Pilgrim License Renewal Inspection Exit Meeting

Nuclear Regulatory Commission

January 30, 2007

Drywell Issue

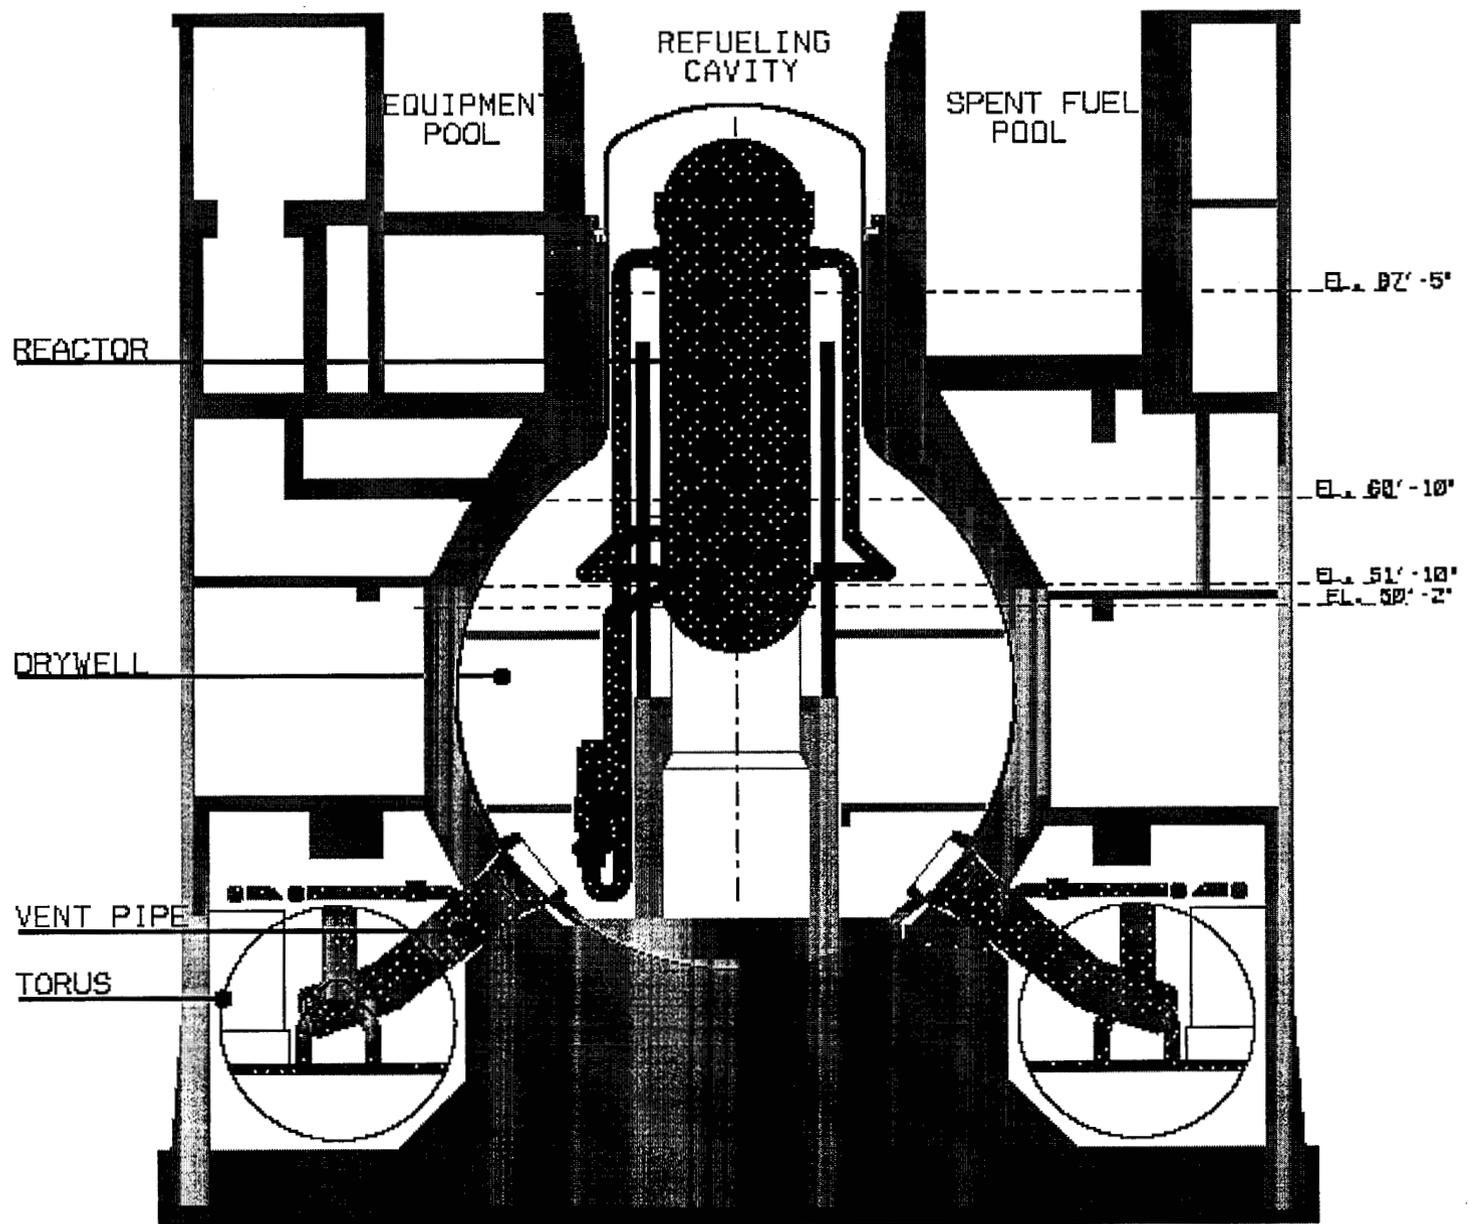
- One open issue to be resolved during license renewal process – drywell
- Seven closed issues, including one with follow-up inspection
- If drywell issue resolved, reasonable assurance of management of aging

- Staff Guidance
- Pilgrim position
- Inspection determinations
